Docket: NRC-2019-0113

Comments on DG-1353 Use of the Frequency-Consequence Curve

Review Comments on Draft Regulatory Guide DG-1353, Guidance for a Technology-Inclusive, Risk-Informed Methodology to Inform the Licensing Basis and Content of Applications for Certifications and Approvals for Non-Light Water Reactors

Figure 1. Frequency-Consequence Curve Interpreted as a Limit on the Complementary Cumulative Distribution Function for Licensing Basis Events

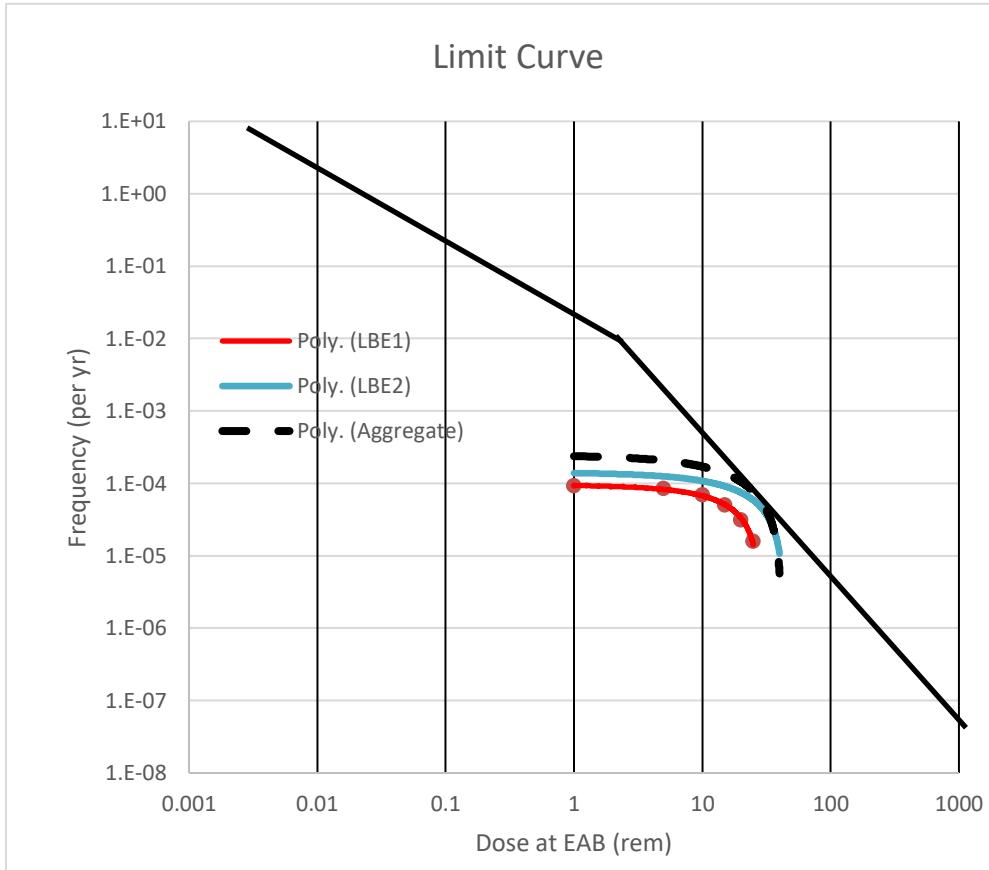
For the DBE and BDBE range we use a slope of -2. The result is shown in Figure 1. In this case the risk contribution from DBEs is determined to be less than 1.5E-4 rem/yr approximately 15 percent of the risk from AOOs. The CCDF limit at 1000 rem is 5E-8/yr, which is more restrictive than the early fatality probabilistic safety goal. The 25 rem dose occurs at 7.5E-5 per yr, which is approximately at the lower bound of the DBE region. The shape of this Frequency-Consequence curve is very similar to the curve in NEI 18-04 other than the low consequence region for which the NEI curve has a discontinuity at the boundary between AOOs and DBEs, which does not exist in the curve we developed. The principal difference is in the interpretation of the curve.

Also shown in the figure are CCDFs for two hypothetical Licensing Basis Events (LBEs) based on uncertainty distributions, as could be developed from best-estimate plus uncertainty analyses. Within the context of NEI 18-04, each LBE would be considered separately. In the proposed reinterpretation of the Frequency-Consequence curve the aggregated CCDF would be required to fall to the left (below) of the curve to satisfy the intended risk constraint. An importance measure has been developed previously to

assess the proximity of a scenario to a limit curve, referred to as a Limit Exceedance Factor [5]. For the example demonstrated, the aggregated CCDF contacts the limit curve, even though the individual CCDFs satisfy the criterion. Whether a 95% uncertainty limit should be added to provide margin to the limit curve is a policy decision that requires discussion. It is our suggestion that the shape of the CCDF for an event would be determined based on aleatory variability and that epistemic uncertainties would be treated as margin on the frequencies and consequences of LBEs.
